Addendum Planning Committee

MEETING OF THE PLANNING COMMITTEE

ITEM NO: 6 PLANNING APPLICATION: 23/00654/F Just Retirement Roebuck House Bancroft Road Reigate RH2 7RP

NOTE: THE PROPERTY OF THIS DRAWING AND DESIGN IS VESTED IN PULSAR TRANSPORT LTD. IT MUST NOT BE COPIED OR REPRODUCED IN ANY WAY WITHOUT THEIR PRIOR WRITTEN CONSENT. © Pulsar Transport Ltd. All rights reserved.

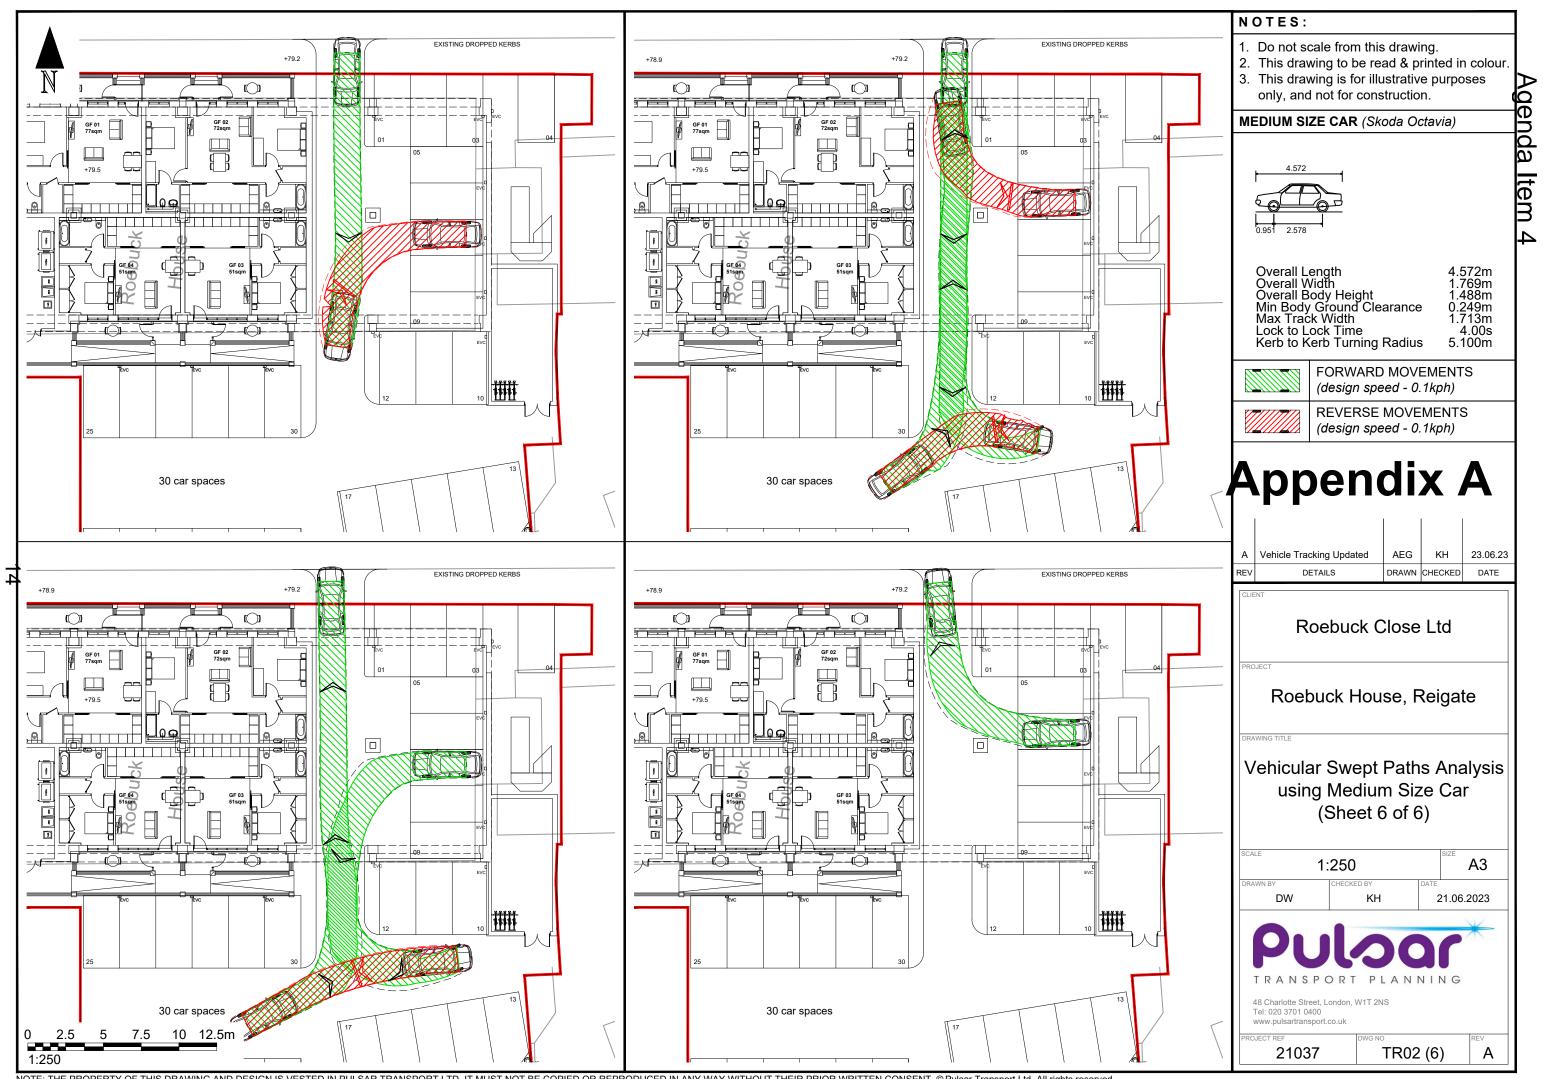
Vehicle tracking plans have been provided demonstrating vehicular movements of a medium sized vehicle entering and exiting a number of proposed parking spaces in both forward and reverse gears. These plans (21037 TR02 A) can be found in Appendix A of the addendum.

Following publication of the report, it has been noted that 3 of the existing parking spaces (1, 3, and 9) as shown on plan number AP261_P101_A, which are proposed for use by future residents of Roebuck House, are impeded by existing pillars within the undercroft of the building. Whilst these spaces are pre-existing and capable of some use, this issue has been reviewed by the County Highway Authority (CHA), who consider that the narrow width of these spaces would make them difficult to enter and exit.

The CHA have advised that if either space 1, 2 or 3 were removed, along with space 9, this would result in a more appropriate layout and would make it clear as to where parking can take place.

To capture the additional spaces and a more optimum parking layout, number and management of the spaces, it is recommended that condition is amended 9 to require a parking layout and management plan.

9. Notwithstanding the submitted plan AP261 P101 Rev A the development hereby approved shall not be first occupied until a revised parking layout and management plan has been submitted to and approved in writing by the Local Planning Authority. The parking layout and management plan shall include numbers of spaces, markings and details of any management including allocation of spaces.
